**IEEE P802.15**  
**Wireless Personal Area Networks**

Project	IEEE P802.15 Working Group for Wireless Personal Area Networks (WPANs)	
Title	<b>TG3 Rolling Meadows Ad-Hoc Working Document</b>	
Date Submitted	[1 November, 2001]	
Source	[James P. K. Gilb] [Mobilian] [12707 High Bluff Dr., Suite 335, San Diego, CA 92130]	Voice: [858-436-2201] Fax: [858-436-2301] E-mail: [gilb@ieee.org ]
Re:	[]	
Abstract	[This document is contains the issues and resolutions developed by the TG3 subcommittee at the Rolling Meadows ad-hoc meeting. It also serves to document the addtions made to the draft standard D07 to produce D08.]	
Purpose	[To provide a record of the resolutions of TG3 and the changes to the draft standard D07 to make D08.]	
Notice	This document has been prepared to assist the IEEE P802.15. It is offered as a basis for discussion and is not binding on the contributing individual(s) or organization(s). The material in this document is subject to change in form and content after further study. The contributor(s) reserve(s) the right to add, amend or withdraw material contained herein.

Figure 3—CTA assignment sequence for pseudo-static GTSs

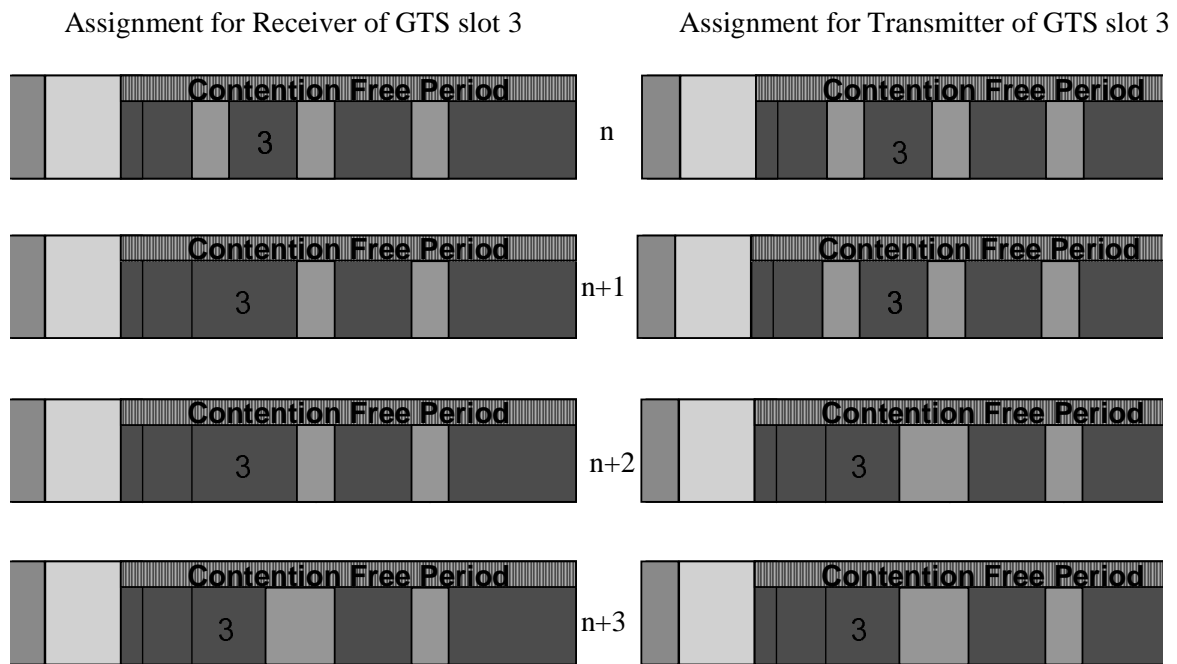
### 6.2.5 New Clause 8.3.3.1.3 Pseudo Static Guaranteed Time Slots

Pseudo static GTSs can be moved by the PNC, but the PNC must notify the affected DEVs by sending them acknowledged Channel Time Grant frames with the new CTA. As with dynamic GTSs, the PNC can rearrange pseudo static GTSs so that the GTS assignments can be optimized, but it must use the Channel Time Grant and coordinate the channel time grants with the CTAs in the beacon.

Before a pseudo static GTS is moved, the PNC shall ensure that the new position is unoccupied by another GTS. Then, the PNC sends a directed channel time grant to the receiving DEV so that the receiving DEV is listening to both the old GTS position and the new position. This channel time grant contains both the old and the new CTA. If the old and the new position overlap, the CTA can be one larger CTA.

Next the PNC sends a channel time grant to the transmitting DEV that contains only the new CTA. By moving the receiver first, the PNC ensures that no frames are lost if Channel time requests are corrupted.

Lastly, the PNC sends a channel time grant to the receiving DEV which only contains the new CTA.

Ed action: The text added is given below:

Pseudo-static GTSs may be moved by the PNC, but the PNC needs to notify the affected DEVs by sending channel time grant frames, 7.5.21.2, with the new CTA. As with dynamic GTSs, the PNC may rearrange pseudo static GTSs so that the GTS assignments will be optimized, but it must use the channel time grant command and coordinate the channel time grants with the CTAs in the beacon.

Before a pseudo static GTS is moved, the PNC shall ensure that the new position is unoccupied by another GTS. Then, the PNC shall send a directed channel time grant to the receiving DEV so that the receiving DEV is listening to both the old GTS position and the new position. The channel time grant shall be acknowledged with an Imm-ACK by the DEV if it is received correctly. If the PNC does not receive an Imm-ACK, it may re-send the channel time grant command, but it shall not continue with the process until the acknowledgement is received. The channel time grant sent by the PNC to the receiving DEV contains both the old and the new CTA. If the old and the new position overlap, the CTA may be one larger CTA.

The PNC shall then send a channel time grant to the transmitting DEV that contains only the new CTA. The transmitting DEV shall acknowledge with an Imm-ACK if it is received correctly. If the PNC does not receive the Imm-ACK, it may re-send the channel time grant command, but it shall not move the pseudo-static GTS until the acknowledgement is received. By moving the receiver first, the PNC ensures that no frames are lost if channel time requests are corrupted.

Finally, the PNC shall send a channel time grant to the receiving DEV which only contains the new CTA. The receiving DEV shall acknowledge this command with an Imm-ACK if it is received correctly. If the PNC does not correctly receive the acknowledgement, it may re-send the channel time grant command. However, the PNC may re-allocate the original pseudo-static GTS even if it does not receive the acknowledgement to the command.

A graphical illustration of the procedure for moving a pseudo-static GTS is illustrated in Figure 3
